ITEM: 6.12	REPORT SUMMARY MINOR VARIANCE APPLICATION FILE NUMBER A126/24
------------	---

MINOR VARIANCE APPLICATION FILE NUMBER A126/24
---	---

CITY WARD #:	1
APPLICANT:	Rossario & Nenzina Bellissimo
AGENT:	Joaquin Diaz Ceballos Zavaleta (Precision Landscaping)
PROPERTY:	7 Lancer Drive, Maple
ZONING DESIGNATION:	See below.
VAUGHAN OFFICIAL PLAN (2010) DESIGNATION:	Vaughan Official Plan 2010 ('VOP 2010'): "Low Rise Residential"
RELATED DEVELOPMENT APPLICATIONS:	N/A
PURPOSE OF APPLICATION:	Relief from the Zoning By-law is being requested to permit an existing cabana in the rear yard, increased lot coverage and reduced soft landscaping requirements.

AS-BUILT POOL, PATIO & CABANA

SP-01

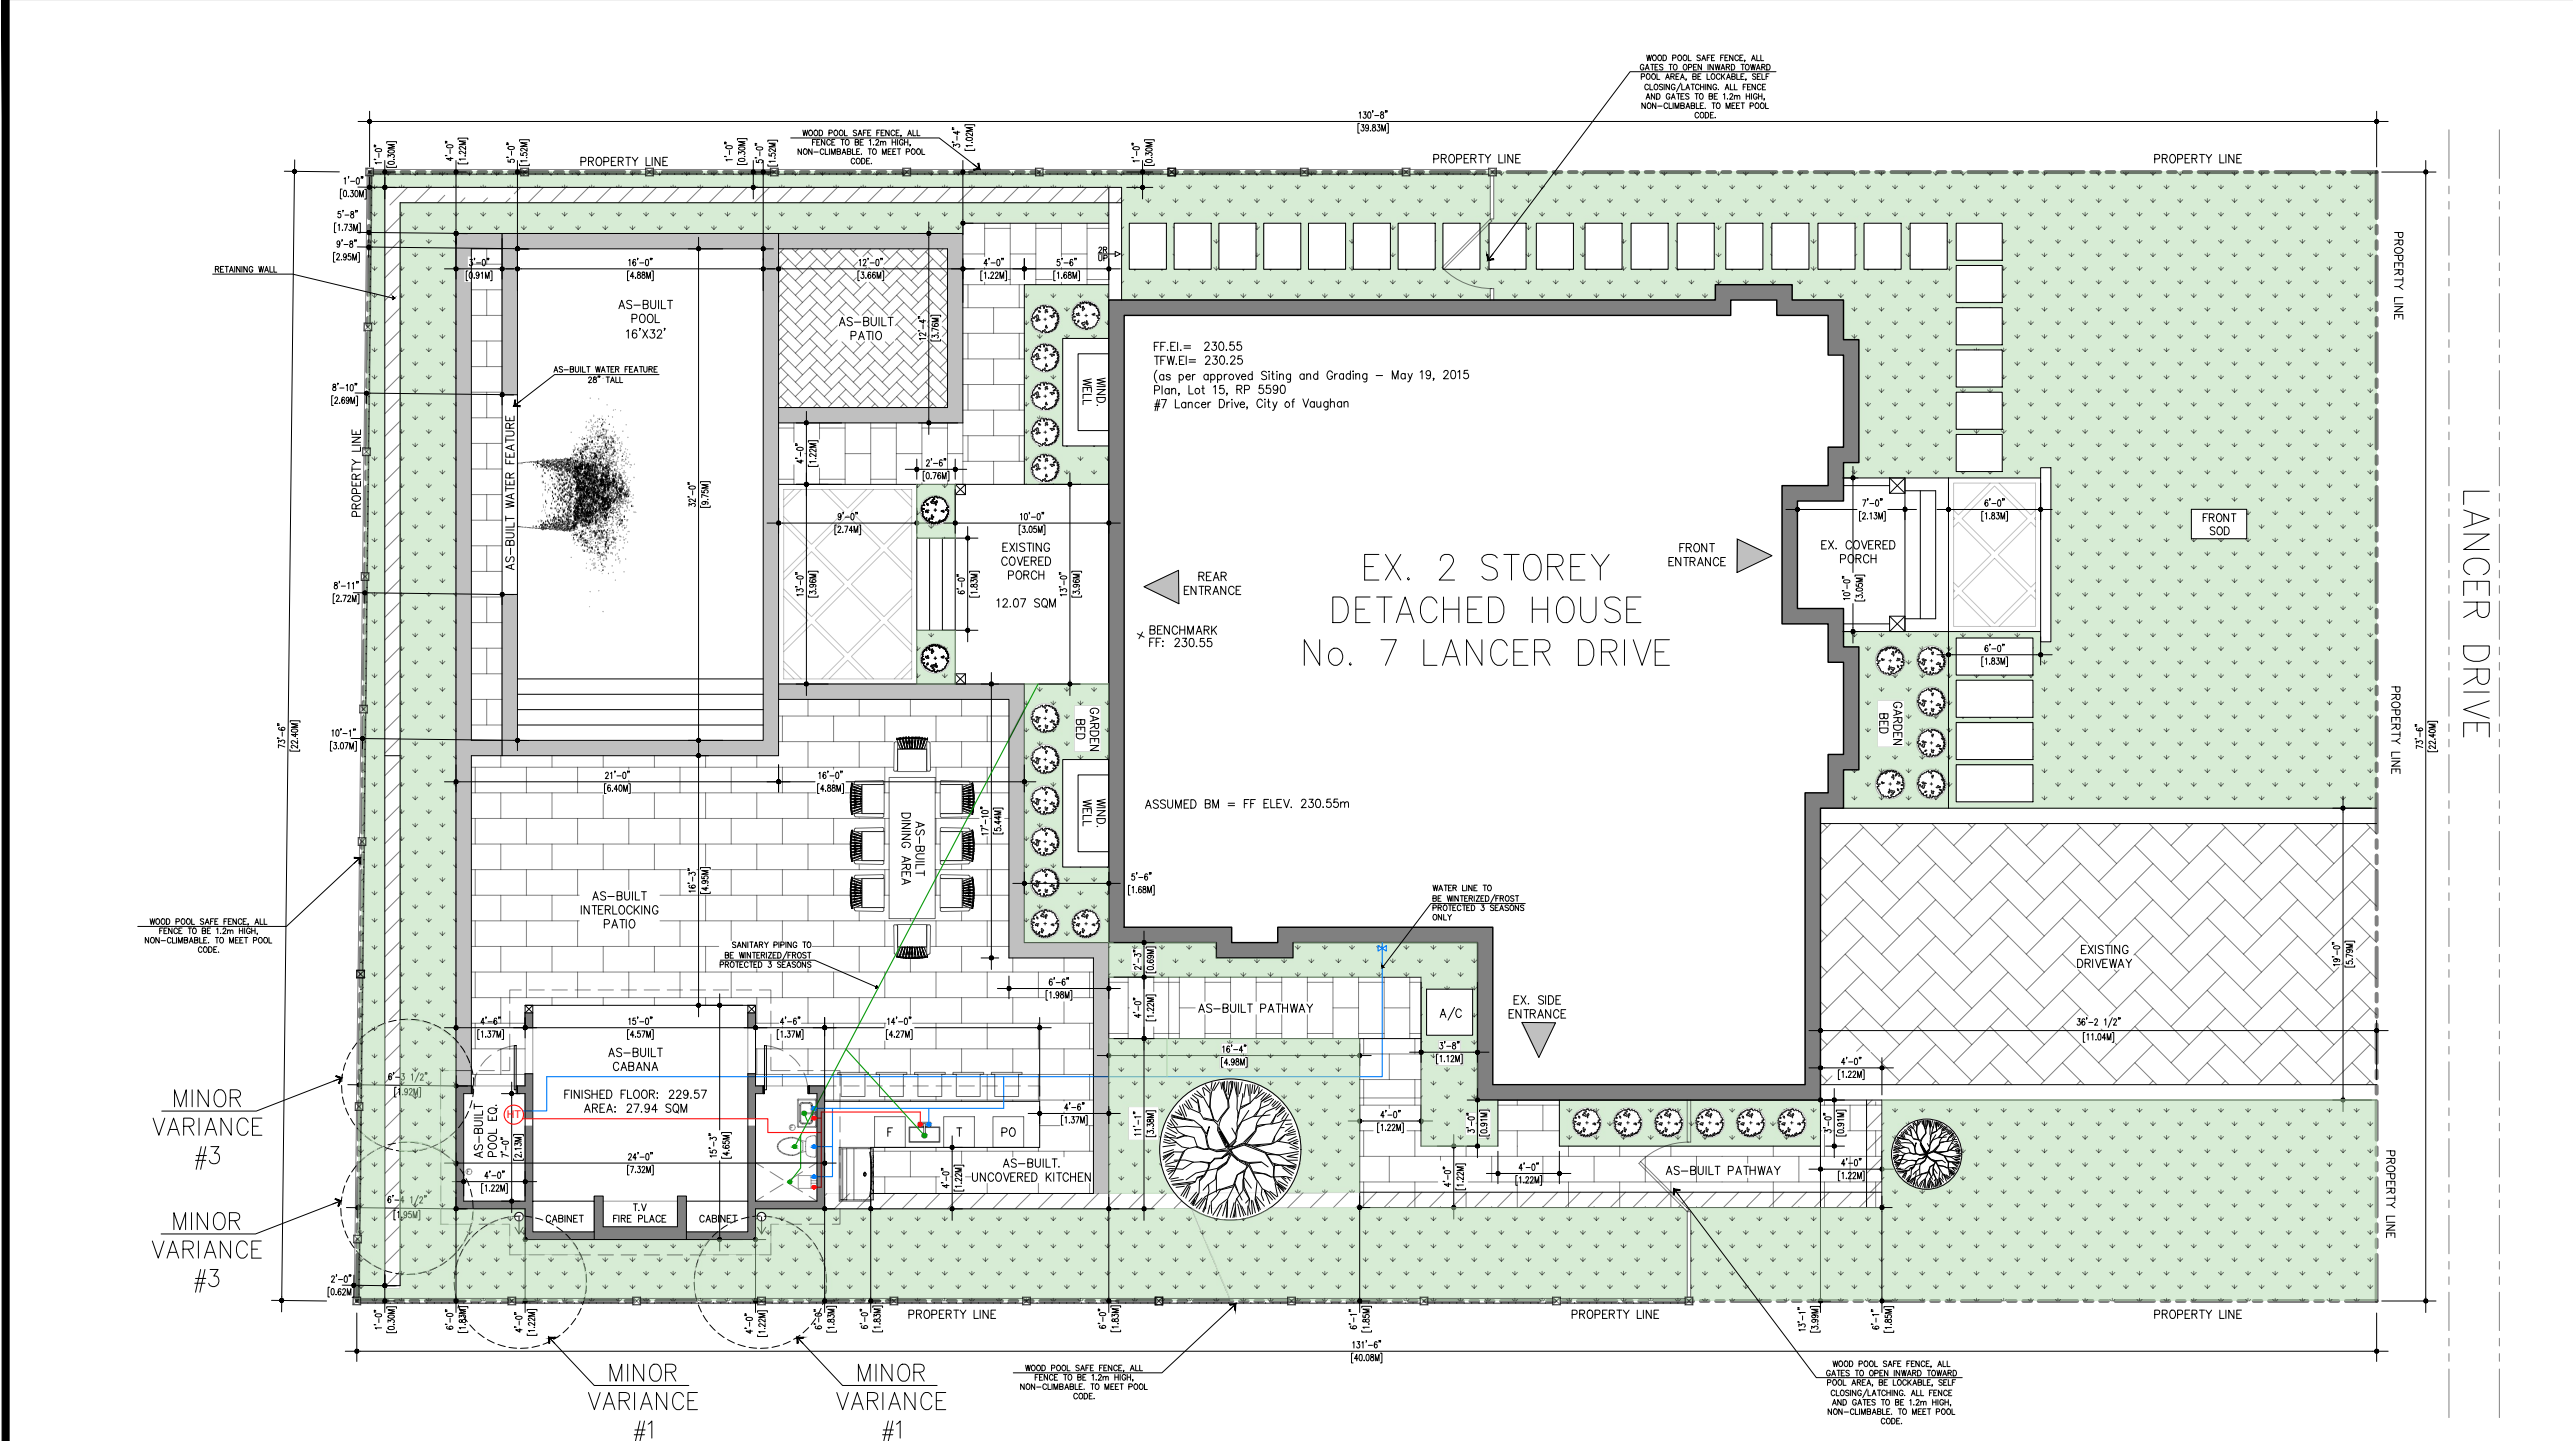
Zoning By-law 001-2021	
1	Maximum permitted lot coverage of 23% is based on the Applicant's confirmation that the existing dwelling is 9.5 m in height (as noted in size chart submitted on this application).
2	The Agent confirms that the retaining wall, located 0.3 m from the rear and interior side lot lines, as shown on the Site Plan, will not exceed 1.0 m in height.

2	The subject lands may be subject to Ontario Regulation 166/06 (TRCA - Toronto and Region Conservation Authority).
3	Limited details about an easement in the rear yard are shown on the Site Plan submitted on Drawing A0 Cover Sheet. Please be advised that it is the property owner's responsibility to determine the limits of the subject property and the existence of any registered easements or restrictions.
4	Proposed lot coverage has been confirmed by the Agent to be as proposed in this minor variance application.
